Document n°  
NT 46-01

Subject: Modification dellorto 28 carburator 290cc 2011

Date/Fecha  
16/01/2012

MATERIAL SUPPLIED BY SHERCO:

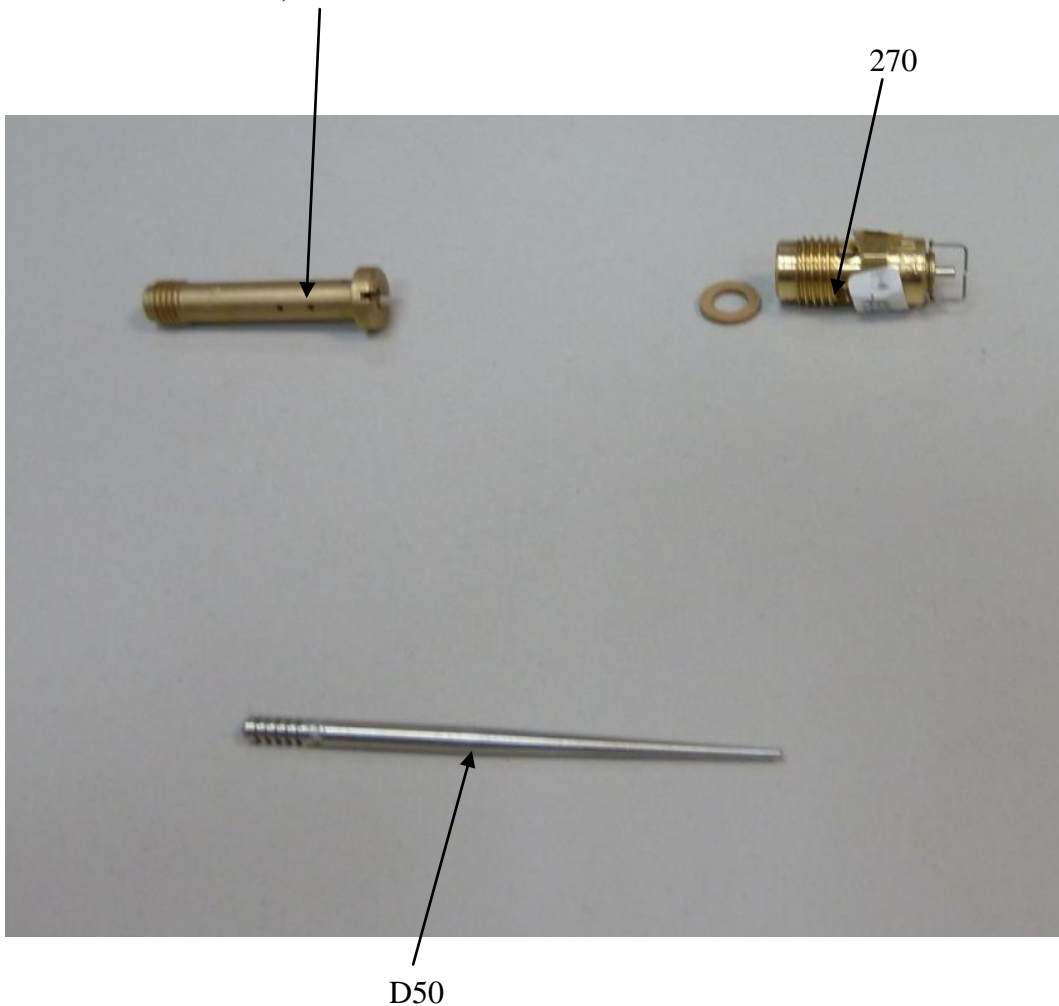
= QUE LA EXISTENTE, PERO SUSTITUIR POR LA SUMINISTRADA POR SHERCO

= L'EXISTANT, MAIS REMPLACER PAR LA PIÈCE FOURNIE PAR SHERCO

= THE EXISTING, BUT REPLACED BY THE SUPPLIED BY SHERCO

## STEP 4

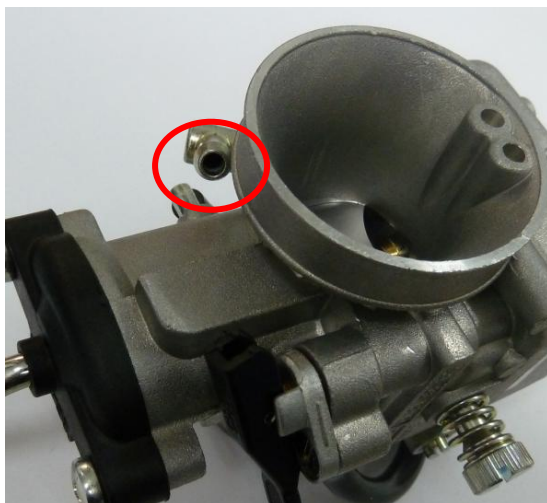
REMOVE BUSHING

ACTUAL (CON CASQUILLO)  
EXISTANT (AVEC ENTRETROISE)  
EXISTING (WITH BUSHING)

SIN CASQUILLO  
SANS ENTRETROISE  
WITHOUT BUSHING

CASQUILLO QUE SE TIENE QUE QUITAR  
ENTRETROISE À ENLEVER  
BUSHING FOR REMOVE
